CITY OF ALBUQUERQUE

April 12, 2022

Re: Champion Xpress
2100 Central Ave. SW
Traffic Circulation Layout
Architect's Stamp XX-XX-XX (J13-D216)

Architect's Response Letter

1 OVERALL SITE PLAN
SCALE: 1" = 20'-0"

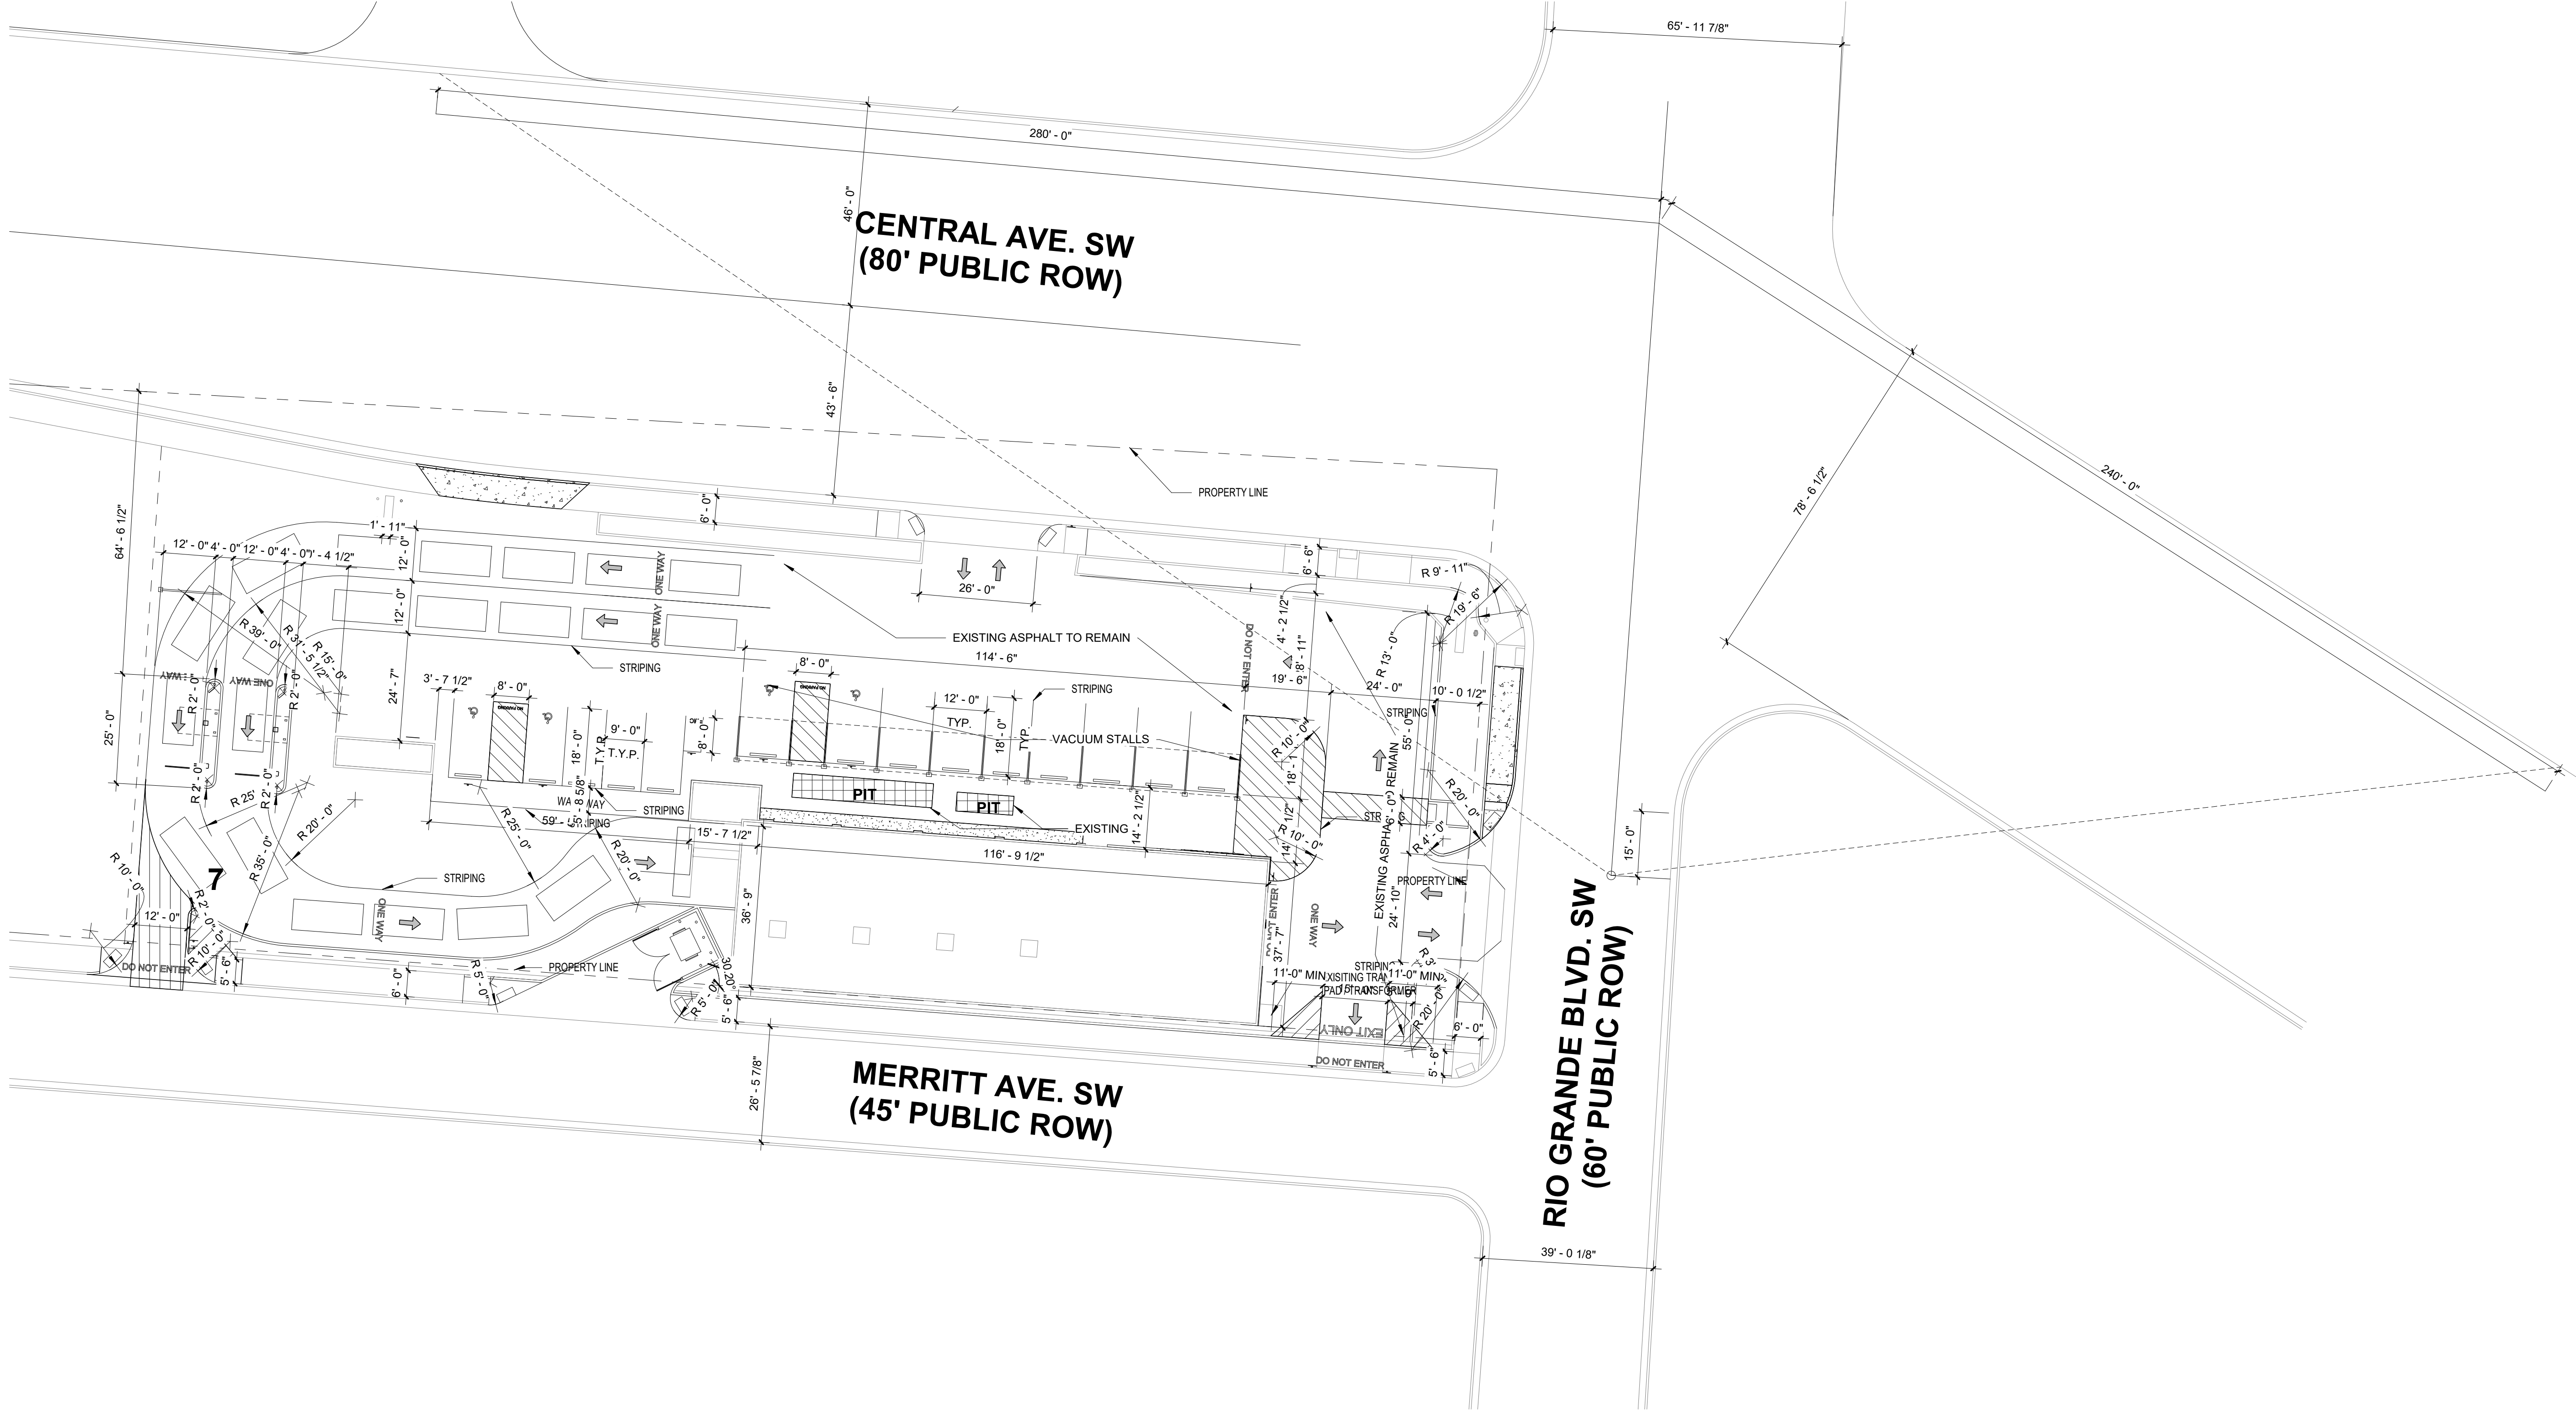
1. The traffic circulation layout must be stamped, signed, and dated by an engineer or architect licensed in the state of New Mexico.
2. Property line showed on site plan is incorrect. Per the GIS, property line must be placed at the back of the sidewalk.

10. Provide a copy of Fire Marshal Approval.
11. Show the Intersection Sight Distance for Central Ave. and Rio Grande Blvd. and add the following note to the plan: "Landscaping and signage will not interfere with clear sight requirements. Therefore, signs, walls, trees, and shrubbery between 3 and 8 feet tall (as measured from the gutter pan) will not be acceptable in the clear sight triangle.

12. Show the clear sight triangle for Merritt Ave. and add the following note to the plan: "Landscaping and signage will not interfere with clear sight requirements. Therefore, signs, walls, trees, and shrubbery between 3 and 8 feet tall (as measured from the gutter pan) will not be acceptable in the clear sight triangle.

33. Show the Intersection Sight Distance for Central Ave. and Rio Grande Blvd. and add the following note to the plane: "Landscaping and signage will not interfere with clear sight requirements. Therefore, signs, walls, trees, and shrubbery between 3 and 8 feet tall (as measured for the gutter pan) will not be acceptable in the clear sight triangle." **Intersection site distances are depicted on the overall site plan sheet G3 With dashed lines.**

34. Show the clear sight triangle for Merritt Ave. and add the following note to the plan: "Landscaping and signage will not interfere with clear sight requirements. Therefore, signs, walls, trees, and shrubbery between 3 and 8 feet tall (as measured from the gutter pan) will not be acceptable in the clear sight triangle. **Site triangles are shown on plan with the minimum 11' – 0". Note has been added to general notes on sheet G3**

2 H.C PARKING PLAN DETAIL (VAN ACCESIBLE)
NTS

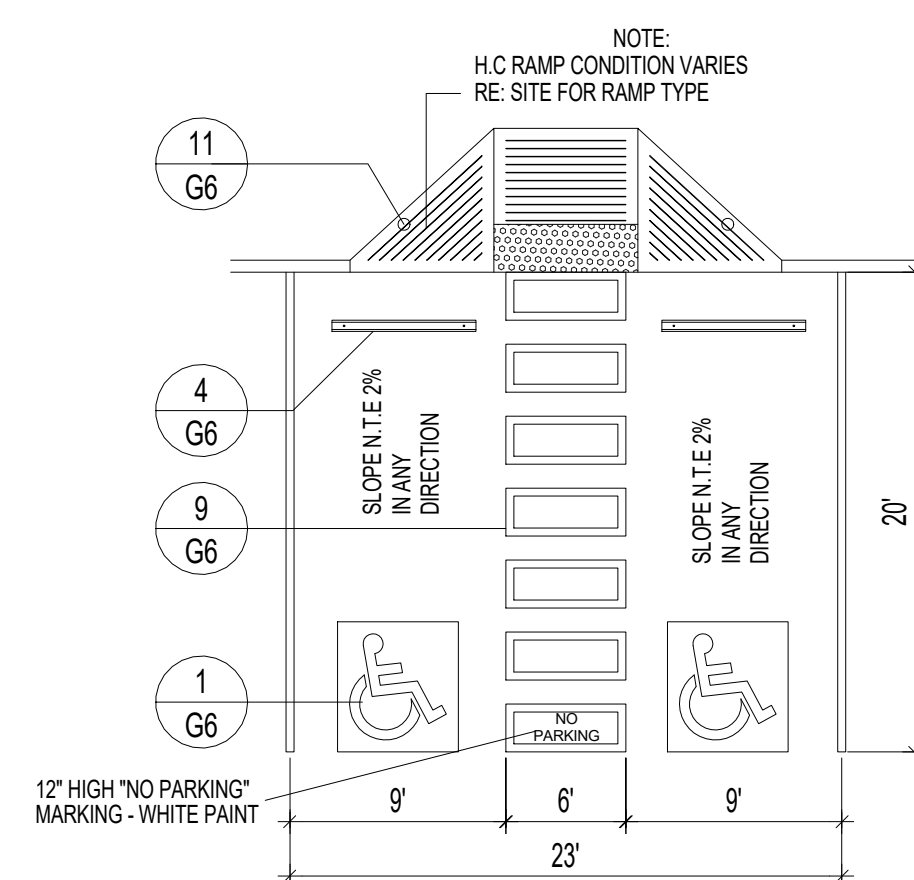
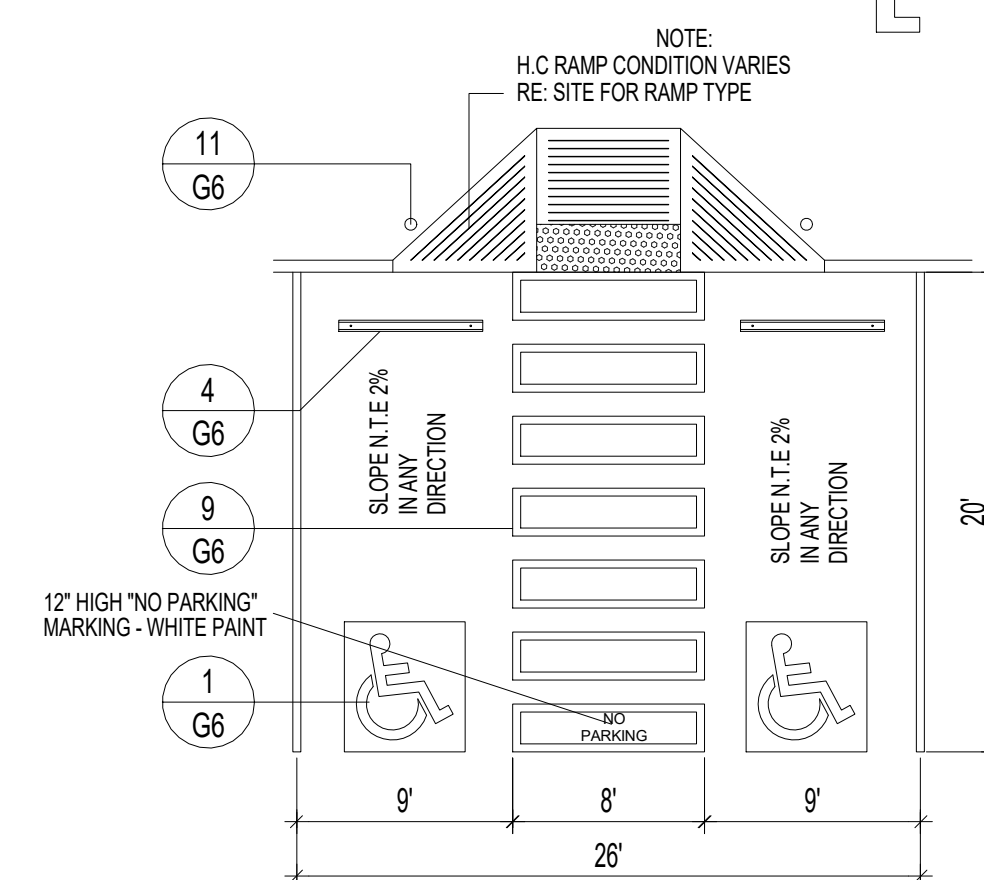
Type of parking	Min. Width	Min. Length	Min. Overhang
Standard	8.5'	18'	2'
Compact	7.5'	15'	1.5'
Motorcycle	4'	8'	N/A
ADA	8.5'	18'	2'
16. The ADA accessible spaces must include an access aisle. Van accessible aisles should be 8ft wide; all others should be 5ft wide. **Both areas with ADA accessible spaces include an 8'-0" accessible aisle.**

18. The ADA access aisles shall have the words **"NO PARKING"** in capital letters, each of which shall be at least one foot high and at least two inches wide, placed at the rear of the parking space so as to be close to where an adjacent vehicle's rear tire would be placed. (66-1-4.1.B NMSA 1978) **ADA access aisles have NO PARKING on each.**

1 H.C SIGNAGE
N.T.S

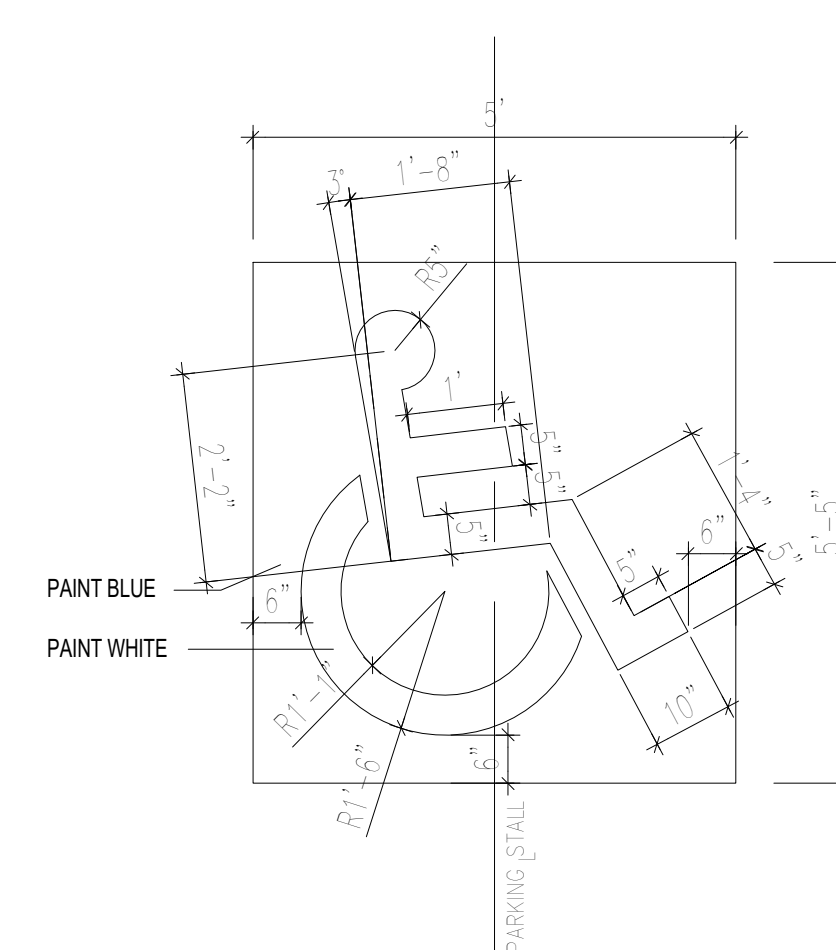
17. The ADA accessible parking sign must have the required language per 66-7-352.4C NMSA 1978 **"Violators Are Subject to a Fine and/or Towing"**. Please call out detail and location of signs. **Both areas with ADA accessible parking have parking signs and the detail can be seen on sheet G6**
